HOMELITE[®]

TECHNICAL SERVICE

NO. 192-001

SUBJECT: HOMELITE VISUAL COMPARISON TESTER
PART NUMBER 18774

INSTRUCTION SHEET FOR GEAR BOX KIT A-04316

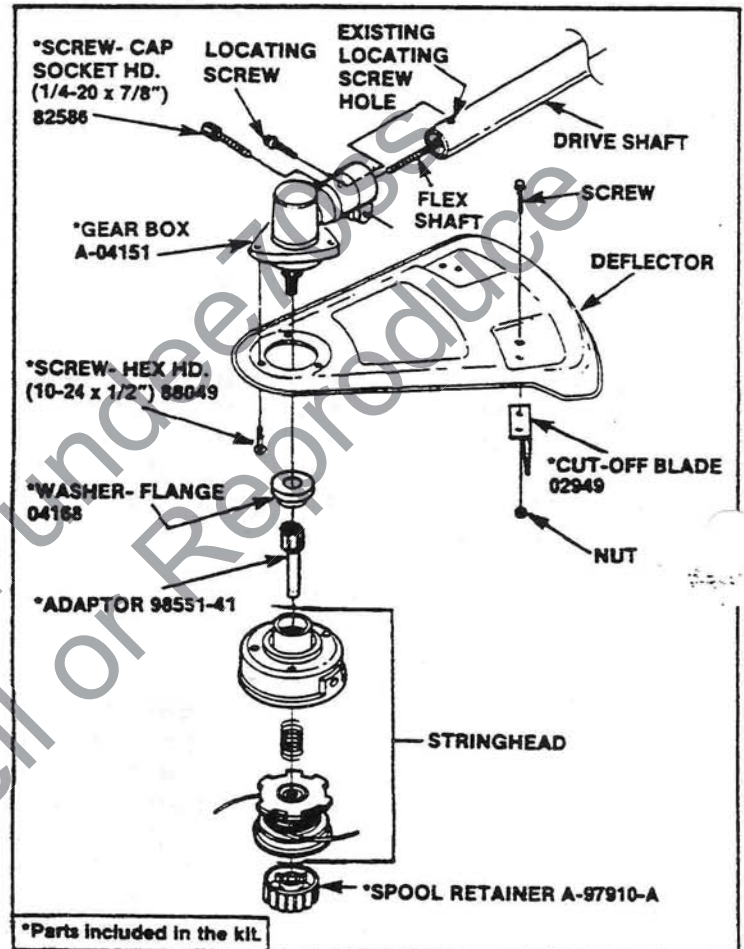
The Service Kit A-04316 should be used when replacing a failed Gear Head on St-285 units.

The A-04316 kit supplies a heavier-duty Gear Head to assure reliability, plus an Instruction sheet to guide proper assembly. The new Gear Head is of reverse rotation (String Head will rotate Counter-Clockwise), but all parts needed for conversion, including left hand Retainer A-97910-A, are included.

1. Remove the stringhead and grass deflector from the gear box (retain parts).
2. Remove the locating screw and the two screws and washers holding gear box to drive shaft. Remove gear box.
3. Install the new gear box (supplied in kit) onto the drive shaft making sure that the flex shaft is engaged with the drive gear and that the gear box is fully seated on the drive shaft.

Be sure top of gear box is aligned with top of engine housing.

4. Without moving the gear box, install the locating screw into the gear box and tighten just enough to mark the drive shaft. Remove the locating screw and the gear box. Drill a 1/4" hole into the drive shaft where the mark was made.

5. Install the new gear box onto the drive shaft. Secure gear box, using the 1/4-20 x 7/8" socket hd. screw and the locating screw (supplied in kit). Tighten fasteners securely.

After installing the new gear box, the stringhead will now turn counterclockwise instead of clockwise as before.

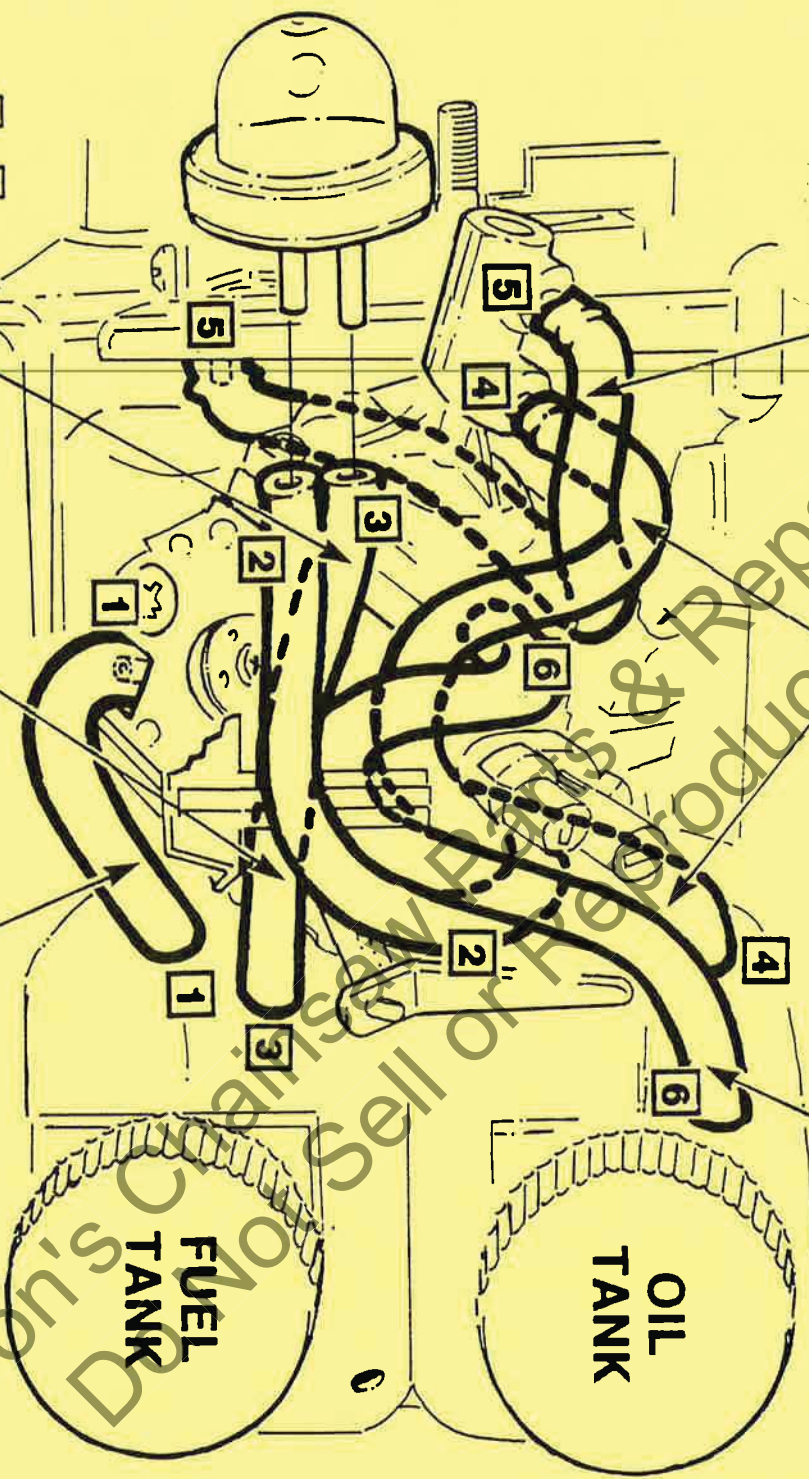
The oil pump on the above listed saws is now part of the carburetor design which may require more running time on some units for oil to reach the bar and chain.

ROUTE LINES AS
 SHOWN - DO NOT KINK.

SUBJECT: AIR LEAK

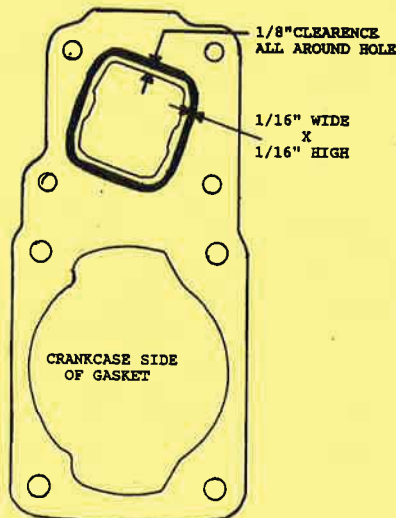
Premature piston and cylinder failures are occurring in the above unit due to an air leak between the carburetor chamber (A93926) and the crankcase (A65736). As a result of changing the material to eliminate asbestos in gasket part number 59771, effective with serial number MK1100001 a change in tolerance went undetected and created this air leak situation. This problem has been addressed on saws produced after serial number HM3260030 by applying silastic on the crankcase side of the illustrated gasket.

- * Use silastic only when using new gasket (Black)
Silastic not required on old gasket (Red)
- * Apply silastic to crankcase side of gasket as shown in illustration.
- * Silastic bead size critical - NO MORE THAN 1/16"
- * **CAUTION:** Do not allow excess silastic to ooze into crankcase intake port, or serious ENGINE DAMAGE could occur.

OIL PUMP ASSEMBLY, A-00007

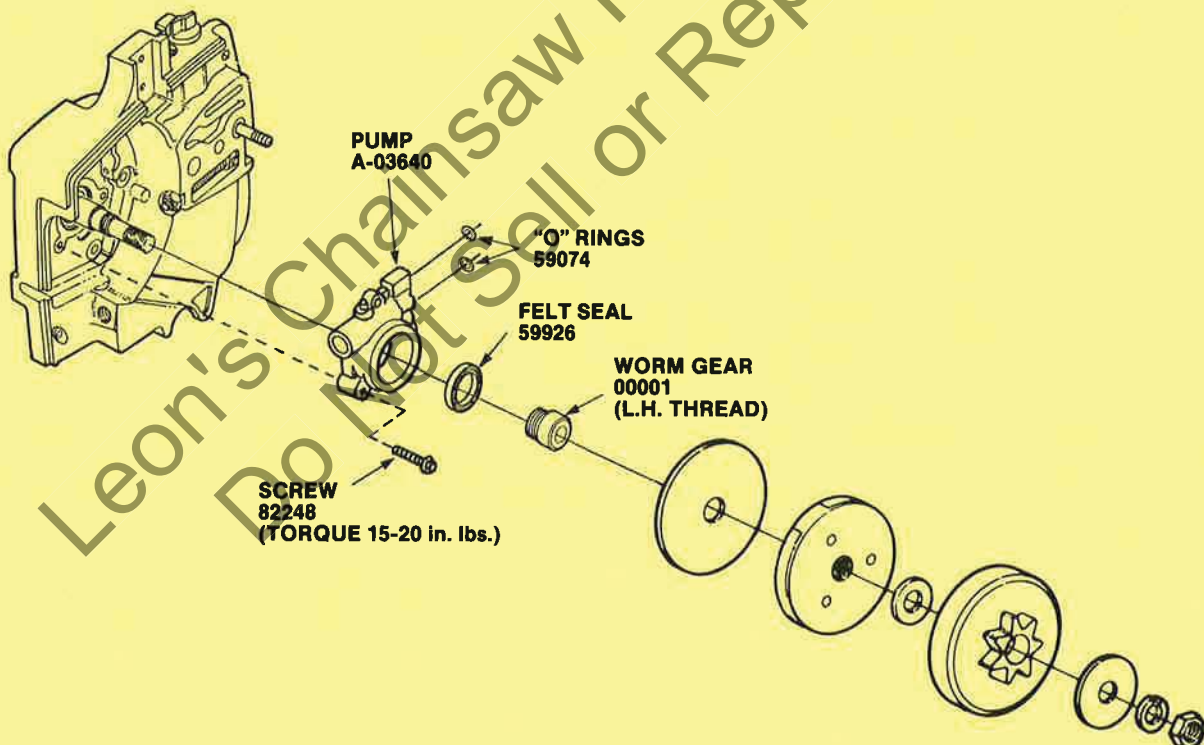
The A-00007 kit includes a new style Pump and Worm Gear, with new mounting screws, and an Instruction Sheet to assure correct assembly. Please note the use of LOC-TITE and proper mounting screw TORQUE are critical to proper assembly of the new pump.

Before installing new pump assembly, refer to illustration below. Make sure (2) "O" rings are in place before installation of pump. Felt seal may be pressed into place before or after pump is installed.

Pump is attached to chain saw body by (3) hex-head screws. Before installing screws, apply a drop of Loctite® Permanent Thread Locker No. 262 to each screw. Then install screws and **torque to 15-20 in. lbs.** Worm gear has left hand thread and is installed into pump and turned *counterclockwise* until seated (see illustration).

FOR CONVERTING MODEL 150 AO TO SOLID STATE IGNITION WITH PARTS FROM KIT #A-97026

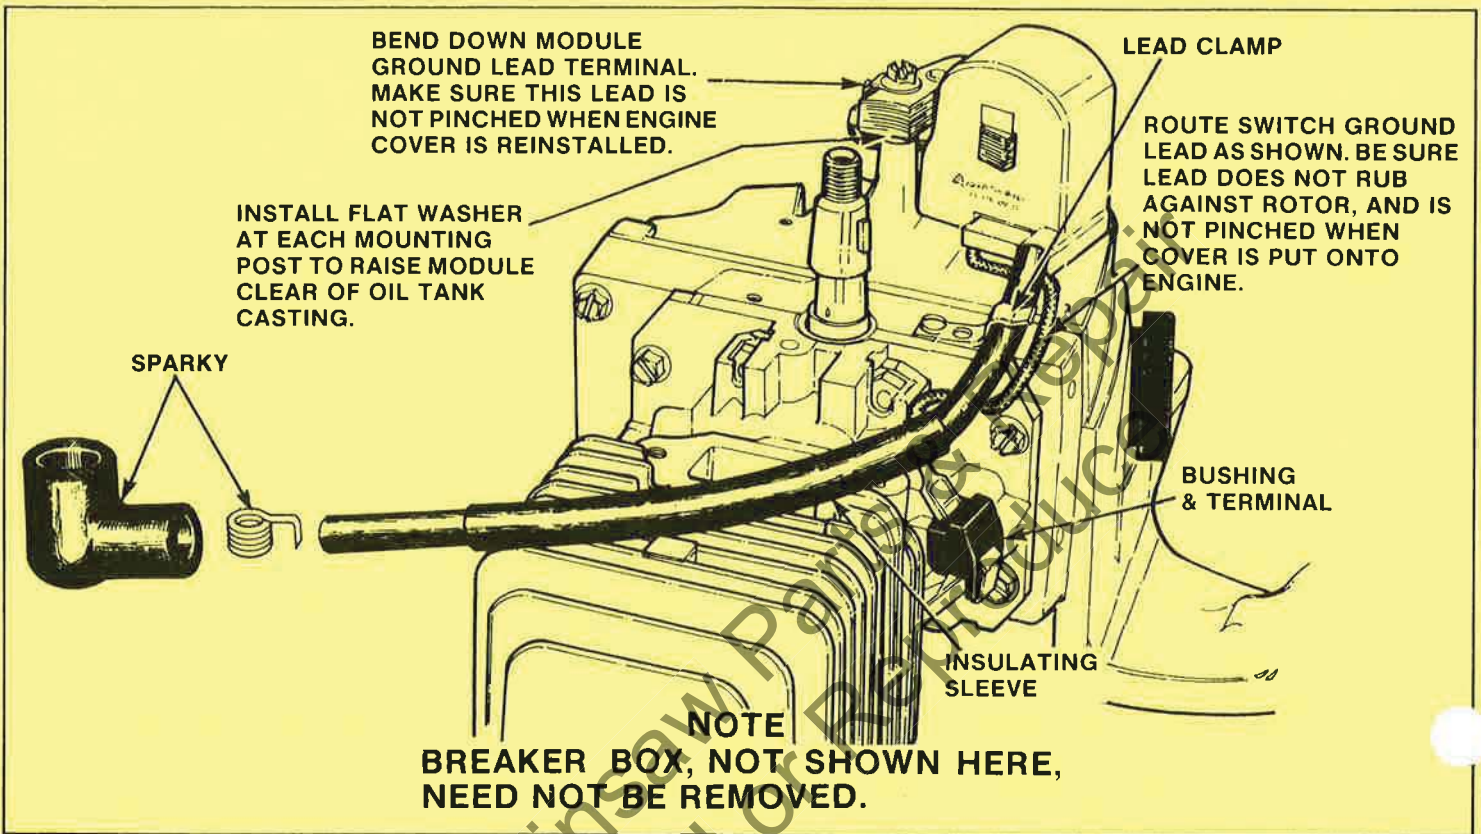
The A-97026 Ignition Conversion Kit is being shipped against dealer orders for the original Model 150 Ignition Coil, as the coil is no longer available.

The Conversion Kit supplies a new solid state ignition unit, plus an Instruction Sheet to assure proper installation.

1. Using #84101 flat washers as spacers between the mounting posts and the module, secure module to unit with two #82248 screws. Note that the short module ground lead must be secured under the head of the bottom screw.

2. Tuck the switch ground lead through the space between the mounting posts and under the module. Route the ground lead as illustrated above.
3. Bend down the terminal of the short module ground lead close to the metal coil core. This is necessary to fit inside the engine cover.

FIGURE #1

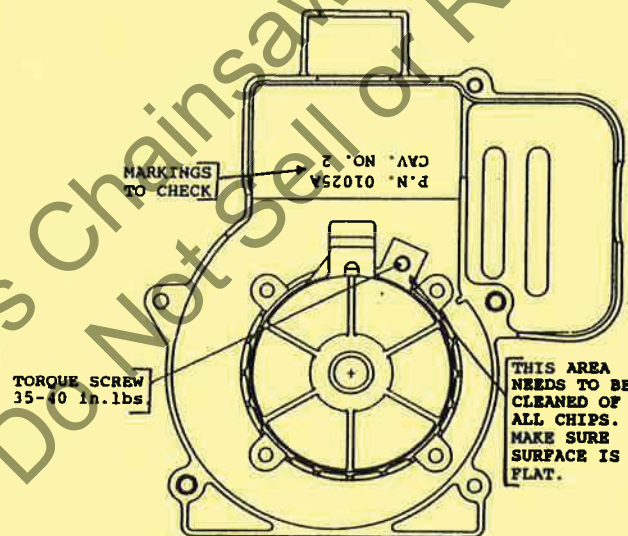
It has come to our attention that a few Non-Clutch Trimmers have had the starter lock up after only a short time. Units that may be affected include those built in December of 1991 (HM336XXXX - HM365XXXX) and January of 1992 (HN001XXXX - HN031XXXX). We have isolated the problem to housings that are marked (P.N. 01025A CAV.No.2) see Fig.# 1 for location of this information.

The problem occurs when the screw holding the retainer is loose. A loose retainer screw can result from excessive flash under the retainer around the hole or the torque on the screw not being set properly. The condition can allow the pulley to lift up and contact the pawls on the rotor. The starter spring then comes out of the can, jamming the pulley against the rotor.

In order to properly repair the trimmer, remove all starter parts from the housing. Check the surface under the retainer. This surface needs to be cleaned of all flash/chips. Make sure the surface where the retainer fastens down is clean and flat. Retighten the retainer screw to a torque of 35 - 40 inch pounds.

NEW HANDLE ASSEMBLY

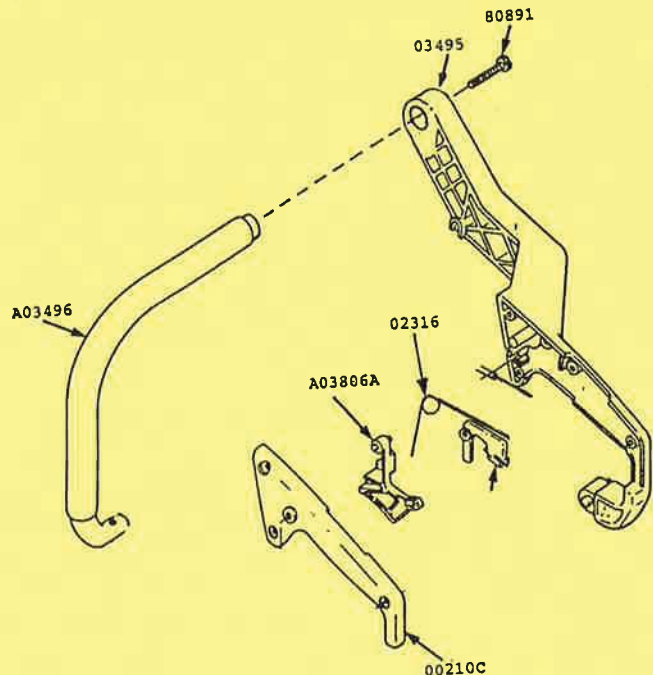
The assembly of the front and rear handles has been redesigned to strengthen the front handle on the above saws. The rear handle no longer has a long taper going into the center of the front handle. The new front handle (A03496) mates to the rear handle (03495) with a screw (80891) directly into the center of the front handle. This will allow the two pieces to fit together more tightly.

The swivel that was on the carburetor is now mounted on the trigger to further improve and simplify adjusting the throttle cable. This change will make the adjustment more convenient when servicing the handle assembly or the carburetor. The throttle return spring and the rear handle cover are also new.

Individual pieces of this new design cannot be interchanged with old handle assembly parts. The following breakdown and listing will give you the new part numbers:
